Office Action Summary	Application No. 10/537,598	Applicant(s) LINNARTZ, JOHAN PAUL MARIE GERARD	
	Examiner NADER BOLOURCHI	Art Unit 2611

DETAILED ACTION

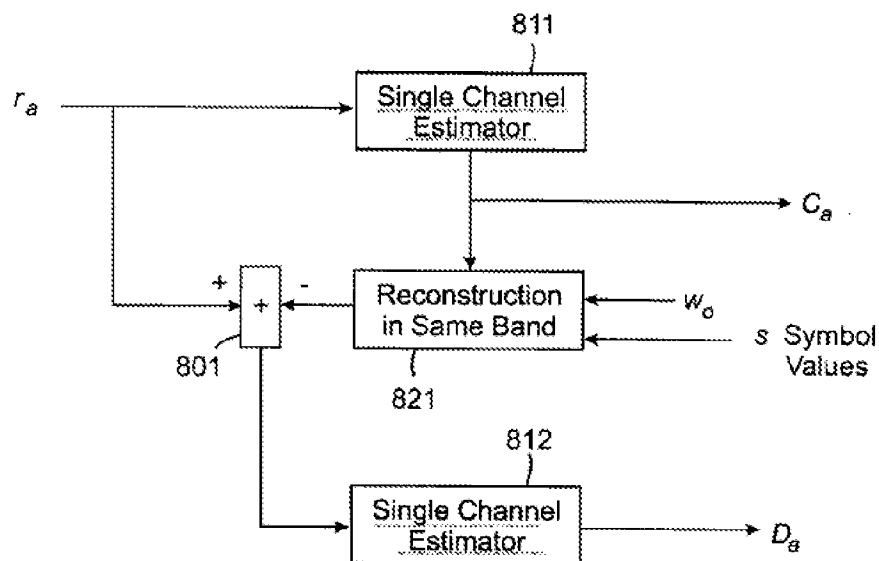
Chennakeshu shows in FIG 8 two pairs of channel estimators 811, 812, or 813, 814. As clearly shown in FIG 6, channel estimator 811 is connected to channel estimator 812 through a summer 801. Similarly, channel estimator 813 is connected to channel estimator 814 through another summer 802.

this is contradictory to the Applicant earlier statements. As disclosed in the last office action in rejection of claim 1, Chennakeshu et al. disclose the channel parameter estimating means in one branch (Fig. 8: 811) are coupled (811 is coupled to 812 through 821 and 801 as shown in Fig. 8) to the channel parameter estimating means in an other branch (Fig. 8: 812), as declared by the Applicant above. (emphasis added):

between r_a with C_a and D_a in Fig. 8) has estimating means for estimating (Fig. 8: 811) at least a receiving channel parameter (Fig. 8: 811; Fig. 8: C_a), and wherein first parameter estimating means in one branch (Fig. 8: 811) is directly coupled (811 is coupled to 812 through 821 and 801 as shown in Fig. 8) to second estimating means in an other branch (Fig. 8: 812) for using at least a part of the channel parameter estimate in the one branch (C_a through 821 and 801 is input to 812 in Fig. 8) as an aid for estimating at least a receiving channel parameter (Fig. 8: D_a) in the other branch.

FIG. 11

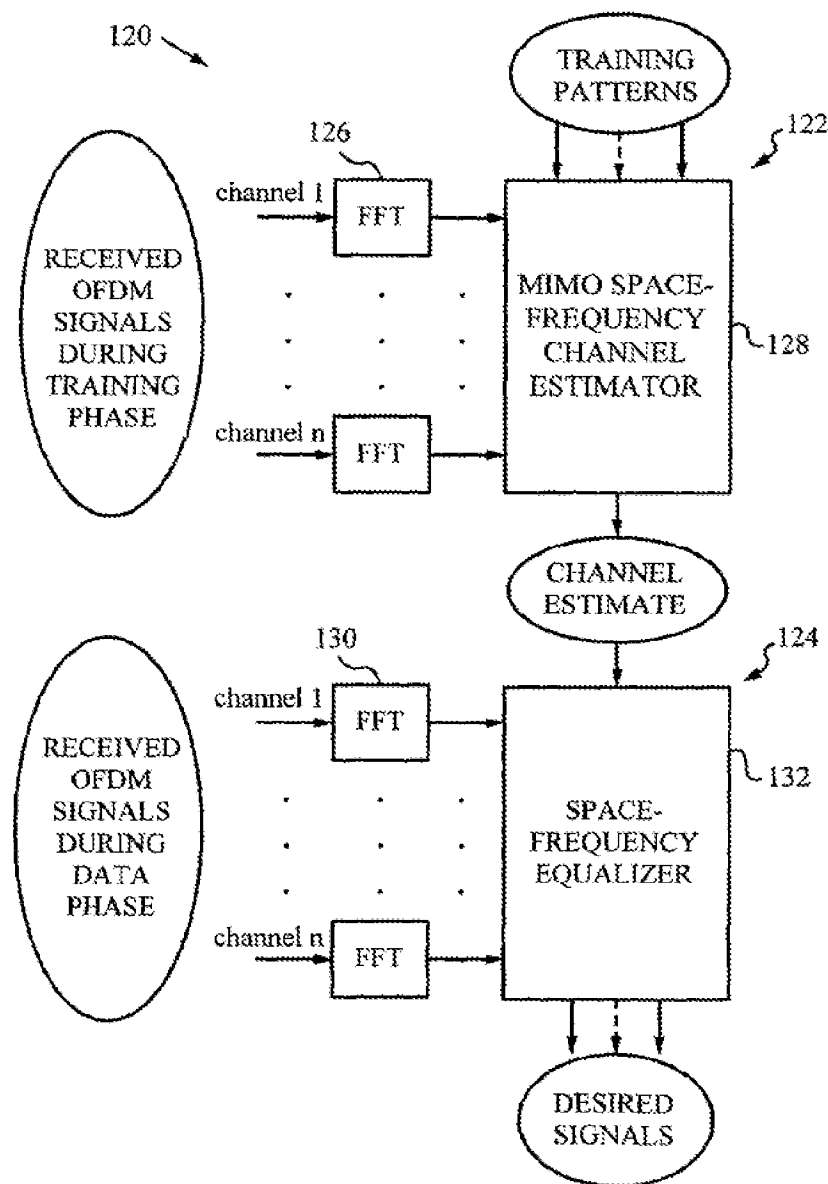
Furthermore, Paulraj et al. disclose the channel parameter estimating means in one branch ("channel 1" in Fig. 11) are coupled to the channel parameter estimating means in an other branch ("channel n" in Fig. 11) (emphasis added):

Regarding claim 1, Paulraj et al. et al. disclose diversity receiver having multiple antenna receiving branches (col. 8: lines 59-64), wherein each branch (Fig. 9: 82A ... 82X) has estimating means for estimating (128, "CHANNEL ESTIMATE", and 132 in combination with FFT of Fig. 11) at least a receiving channel parameter ("DESIRED SIGNAL" in Fig. 11), and wherein first parameter estimating means in one branch ("channel 1" in Fig. 11) is directly coupled to second estimating means in an other branch ("channel n" in Fig. 11) for using at least a part of the channel parameter estimate in the one branch ("FFT" 126 of "channel 1") as an aid for estimating at least a receiving channel parameter in the other branch ("FFT" 130 of "channel n").

second received channel in the second branch and forming second channel estimation ("DESIRED SIGNAL" due to "channel n" in Fig. 11).
